Publication

COVERING 1956-1960 VOLUME 11 No. 1 THROUGH VOLUME 15 No. 6

Published and Distributed by RECEIVING TUBE DEPARTMENT

This G-E HAM NEWS THIRD BOUND VOLUME has been published in answer to many requests for the complete set of issues from January-February, 1956 (Vol. 11, No. 1); to November-December, 1960 (Vol. 15, No. 6). Also, much additional information has been compiled about most of the original articles and combined into a 72page supplement at the rear of this volume.

FIG. 4 CLOSE-UP VIEW SHOWING THE VERTICALLY-POSITIONED 0.001-MFD. SECOND RF AMPLIFIER GRID BY-PASS CAPACITOR SHIELDING THE PLATE CIRCUIT IN THIS STAGE FROM THE SMALL-DIAMETER CATHODE COIL, L₃, NEAR THE CENTER OF THE PICTURE.

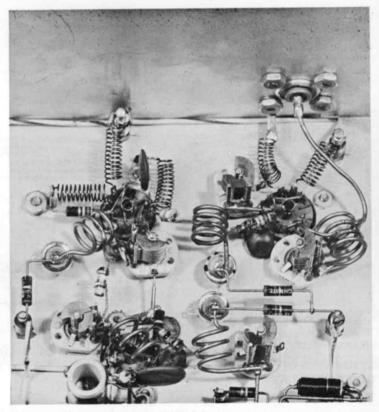
- 4. Newer crystals for the 3rd and 5th overtones make possible a simplified oscillator circuit. Use one section of the 12AT7 as the oscillator in the circuit the crystal manufacturer recommends, and the other section as a doubler (for 60 to 70-Mc. range crystals), or a tripler (for 40 to 46-Mc. range crystals).

DIAGRAM SHOWING CIRCUIT CHANGES TO ADD CENTERING CONTROLS TO THE HAMSCOPE.

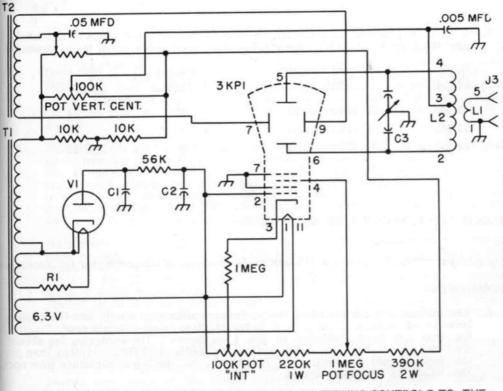
- 10. A number of readers have inquired about converting the war surplus BC-929 oscilloscope to the HAMSCOPE circuit. An article has been published in QST magazine for August, 1957, page 32, describing the conversion of this oscilloscope to a modulation monitor similar to the HAMSCOPE, but with more elaborate circuits.
- 11. Since the side view photo, Fig. 3, and layout drawings Fig. 5 and Fig. 6 in the original issue are pinched in the binding of the bound volume, these illustrations are repeated here.

PARTS LIST FOR SIMPLIFIED SCHEMATIC DIAGRAM G-E HAM NEWS 100-WATT MOBILE POWER SUPPLY FROM JULY-AUGUST, 1957 ISSUE

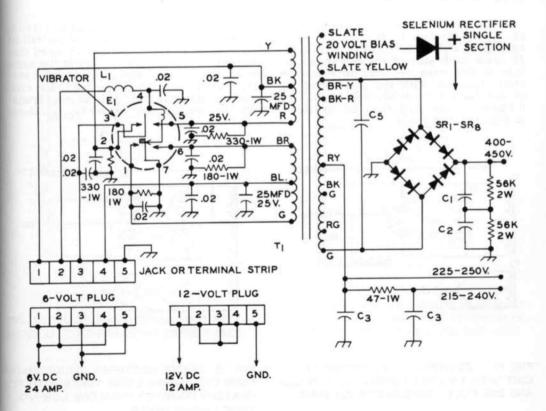
1. "The case of the missing 'O'--in Figure 12," the schematic diagram for the mobile tube heater circuit, the current balancing resistors in the circuits of "A" and "B" should be 10 ohms, and not 1 ohm, as was shown in these diagrams. The correct diagram is repeated at the right.

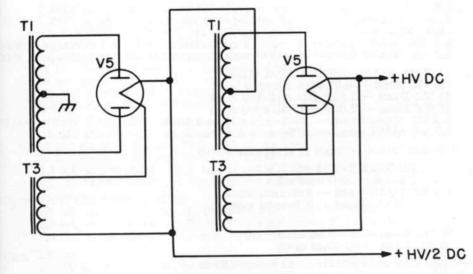
Another circuit for a dual-voltage power supply, which we did not publish may be made by connecting the output of two separate full-wave rectifiers in series. One full wave rectifier is operated with the high voltage winding center tap grounded, as shown in Fig. 17. The positive voltage from the cathode of this rectifier is then connected to the center tap on the high voltage winding of a second full-wave rectifier. A total current about one and one-half times the continuous duty current rating of the transformers may be drawn from this power supply when the transformer heater windings are not used.

FIG. 1. SCHEMATIC DIAGRAM FOR A THREE-STAGE VERSION OF THE SINGLE BAND TRANSMITTER COVERING BOTH 14 AND 21 MEGACYCLES.

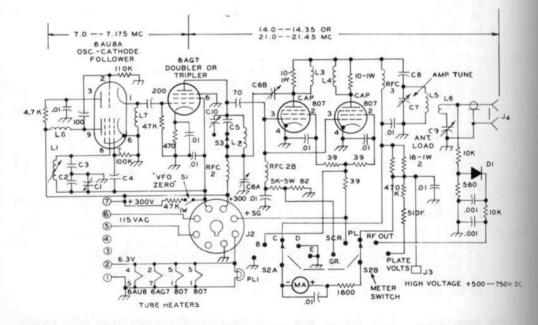
A three-stage version of the single bander transmitter has been tested on the 21 and 28-megacycle bands. In it, an extra dual-purpose tube (6AU8 pentode-triode) has been added as a combined high-C oscillator--cathode follower isolating stage. The 6AG7 tube then operates as a frequency doubler to drive the final amplifier. A block diagram of this tube lineup is shown in Fig. 1 below. Better frequency stability under keying and plate modulation has resulted, as compared to the original two-stage lineup. However, the 3.5 and 7-megacycle models of the two-stage rig have excellent frequency stability under modulation.

This three-stage circuit also can be adapted to the lower frequency bands, by including the component values shown in the tabulation on page 3 of the January-February, 1958 issue; and, the additional information on components given on the preceding pages of the supplemental information for this transmitter. Coils L_7 and L_8 in the oscillator circuit are 0.5 mh. RF chokes.

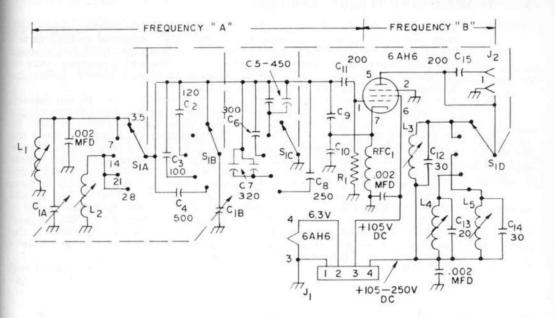
- 1. CHANGES IN PARTS LIST:
 - a. C_{13} on diagram The last capacitor in the PARTS LIST, shown as C_{15} , a 20-mmf silvered mica, actually is C_{13} on the diagram. The " C_{15} " shown with C_{11} is correct.

- b. A revised description of the 7-megacycle tuneup follows: Do not disturb the adjustment of L_1 , as previously adjusted during the 3.5-megacycle tuneup, or else the 3.5-megacycle calibration will be changed. Turn S₁ to the 7-megacycle position and C₁ to maximum capacitance. Check the oscillator frequency, and, if it is found to be below 7 megacycles change the 50-mmf capacitor on C₅ to 30 mmf. This should move the lowest frequency up to about 7.01 megacycles with C₁ at maximum capacitance. If the oscillator is found to be about 7.05 megacycles when it is first checked, change the 50-mmf capacitor on C₅ to 70 mmf. This should bring the frequency down to about 7.01 megacycles. If the frequency is still high, add a 10-mmf silvered mica capacitor across the 70-mmf capacitor, installed as part of C₅. With C₁ at minimum capacitance, the oscillator frequency should be about 7.35 megacycles after the low frequency end of the tuning range is adjusted.

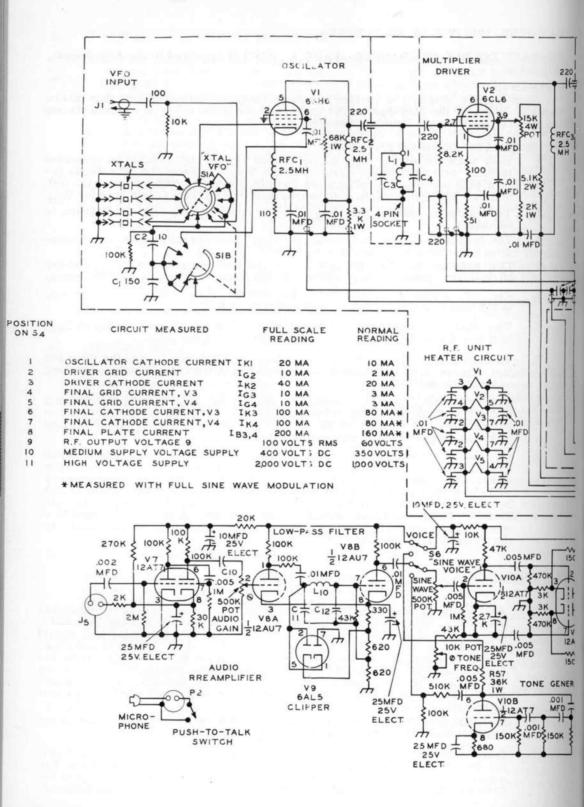
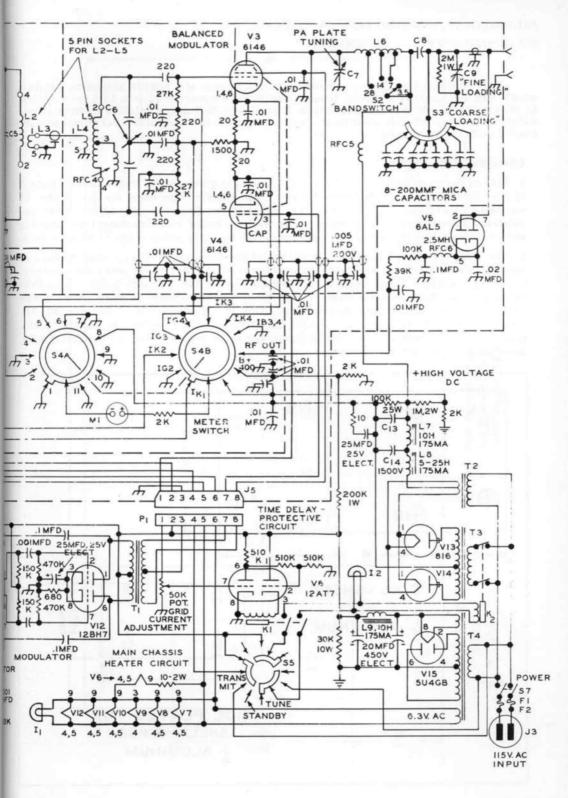
This section contains a revised schematic diagram larger in size than that on pages 4 and 5 of the May-June, 1959 issue, and additional notes on components and operation of the 200-watt Doublesidebander.

- 8. The full-scale current reading on the meter, M_1 , with S_4 in position 3 (Driver Cathode Current) should be 40 ma., with the 51-ohm resistor in series with the cathode of the 6CL6 (V_5). For a full-scale meter reading of 50 ma., change this 51-ohm resistor to 39 ohms.

- 9. Only two pilot lamps, I_1 and I_2 , are shown on the schematic diagram, although three lamps are shown in the front view picture on page 3 of the May-June issue. This extra pilot lamp actually was connected across the primary of T_3 and lit only when power was actually being applied to T_3 . The switch S_5 was wired somewhat differently, so that when K_1 closed, I_2 would light in the "TUNE" position, indicating that sufficient grid drive to the 6146's was available to permit application of high voltage when S_5 was turned to the "TRANSMIT" position.
